Questions about LAA deployment scenarios

Document	IEEE 802.19-15-0060-01-0000		
Submitted	2015-08-04		
Source	Roger B. Marks BaiCells r.b.marks@ieee.org +1-802-capable		
Abstract	This document discusses realistic unlicensed LTE deployment scenarios and their requirements for license-assisted access, proposing some questions for 3GPP.		
Purpose	Purpose For review by the IEEE 802.19 WG and incorporation into comments into IEEE 802 input to 3GPP LAA workshop of 2 August 2015.

Figure 6-1: LAA deployment scenarios

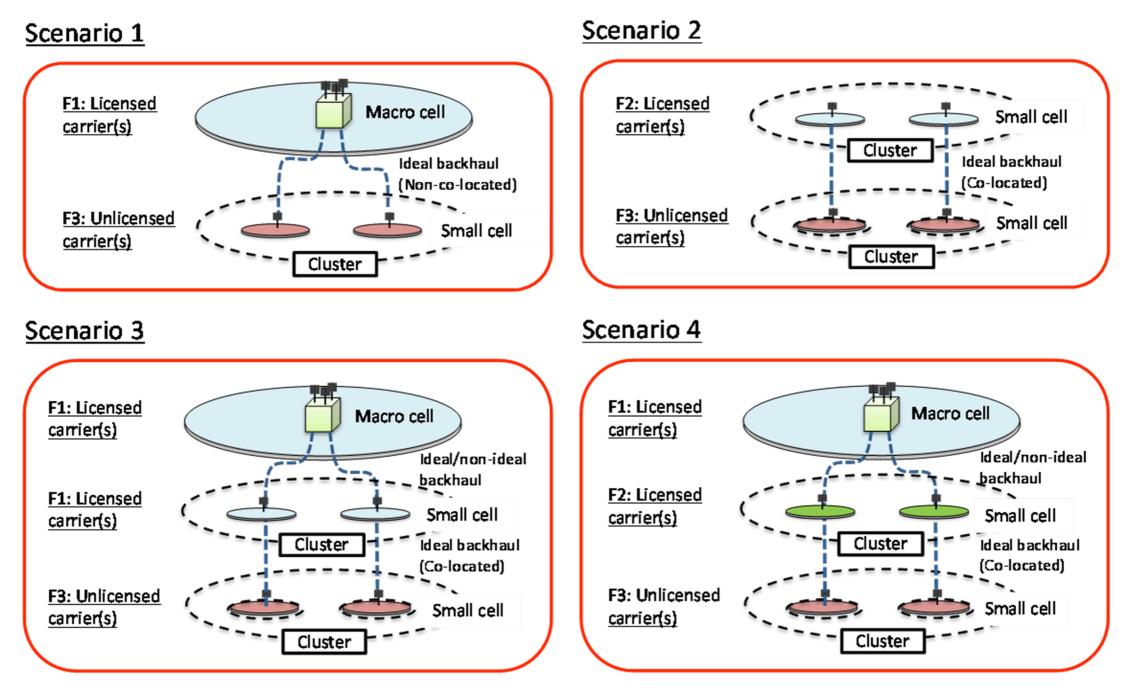
- Scenario 1 presumes Licensed band in macrocell, not microcells
 - Is a solution that requires a licensed microcell at each unlicensed microcell really practical?
- In Scenario 1, Unlicensed Small Cell is connected to network by "Ideal Backhaul"
- "Ideal Backhaul" is really "fronthaul"
 - Carrier Aggregation takes place in the MAC
 - downlink and uplink resource scheduling is done is at a unified MAC
 - PHY I/Q channels distributed to "remote radio heads" via (e.g.) CPRI
 - ~hundreds of Mbit/s per 20 MHz channel, per antenna
 - with synchronization provided
 - for a number of unlicensed microcells within a large licensed macrocell, it's an expensive proposition

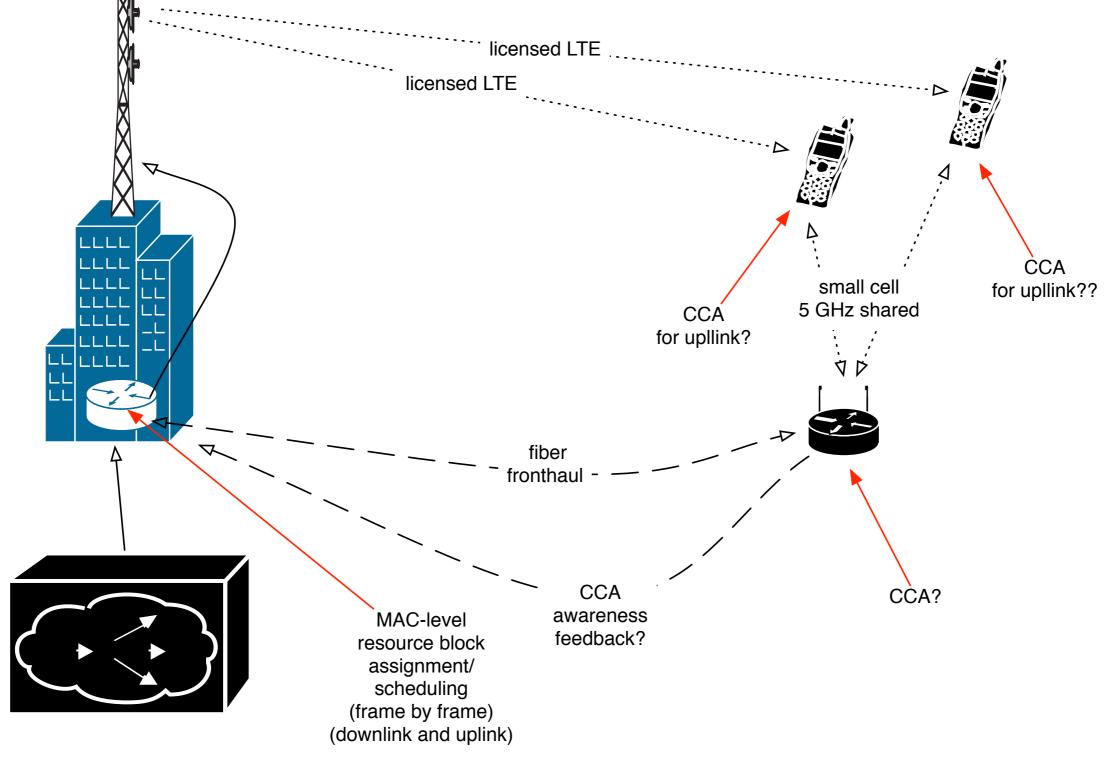
Which "equipment" does the CCA?

How does the timing work?

Figure 6-1: LAA deployment scenarios

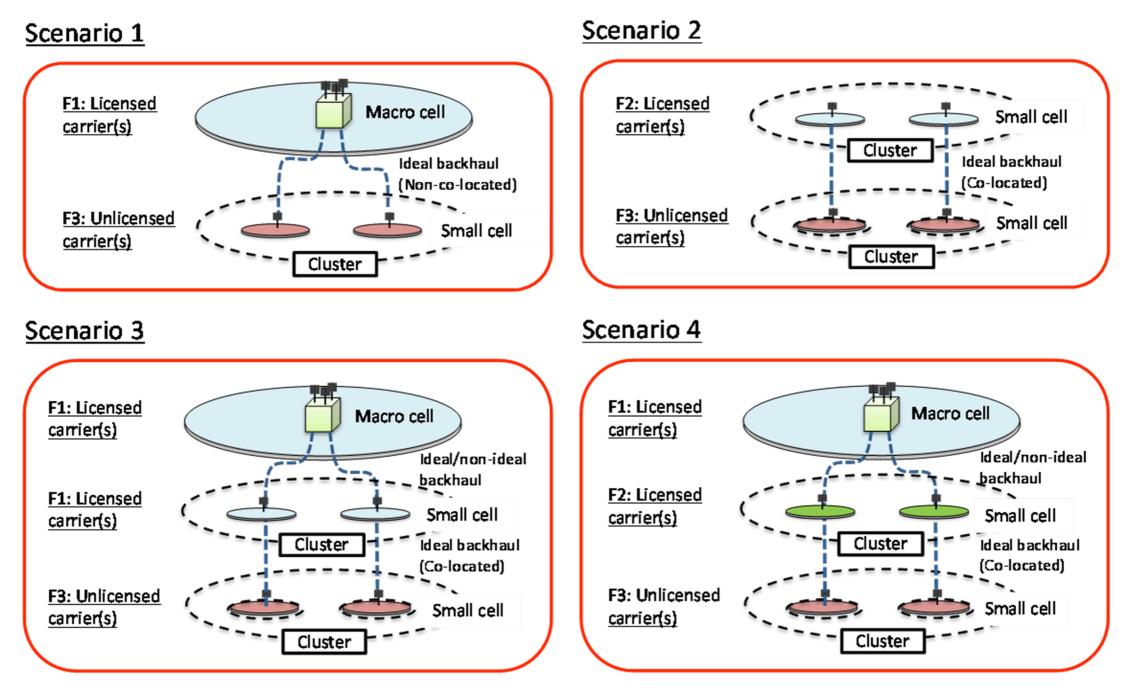
- Possible outdoor scenarios are Scenarios 1, 3, 4
 - Scenario 4 is evaluated in TR 36.889
 - limited in applicability in that it requires different licensed bands for macro and small cell
 - Scenarios 1 and 3 are not evaluated in TR 36.889
 - these are also problematic

- Requires "ideal backhaul" between the macro site and the unlicensed small cell.
- Baseband and scheduling take place at the macro site; small cell is a remote radio head.
- CCA must take place at the small cell, and at remote UE when uplink is supported.
- Is the scheduler aware of remote CCA status?
 - If so, what is the effect of latency in non-quite-ideal backhaul, and over-the-air latency in passing CCA status from UEs when uplink is supported?
 - If not, is this still a Carrier Aggregation system?

- Macro and small cell share the same licensed band.
- Comparable to Scenario 3 of TR 36.872
 - Macro and small cell licensed bands may require detailed scheduling and synchronization.
- Scheduling issues similar to Scenario 1, depending on whether backhaul to macro is ideal.
 - For this scenario, TR 36.872 notes that "Proposals considering backhaul assumptions should analyze the influence of these assumptions on the delivery of the information to be exchanged and on the access network performance metrics."
 - This note should be considered very carefully in the context of LAA, which tries to aggregate a third carrier that must operate under CCA.

Figure 8.1-1: LAA evaluation scenarios

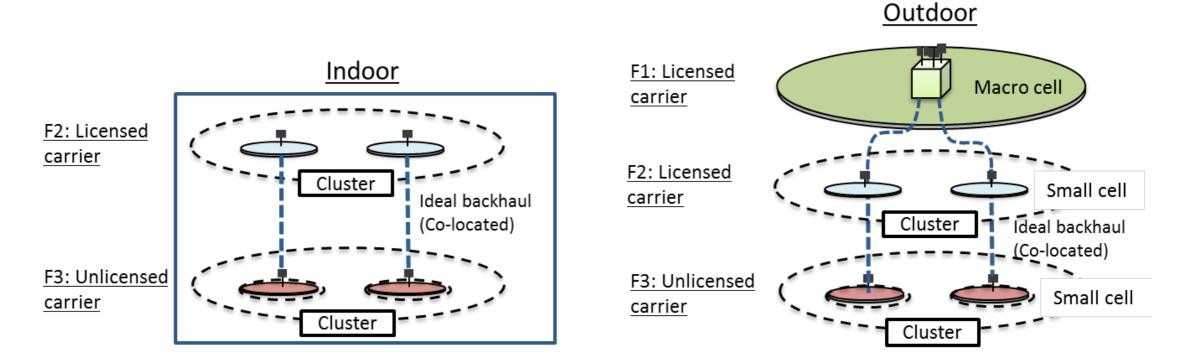
- per TR 36.889, indoor scenario based on Scenario 3 of TR 36.872
 - but comparable to Scenario 2 of TR 36.889
- per TR 36.889, outdoor scenario based on Scenario 2a of TR 36.872
 - but comparable to Scenario 4 of TR 36.889
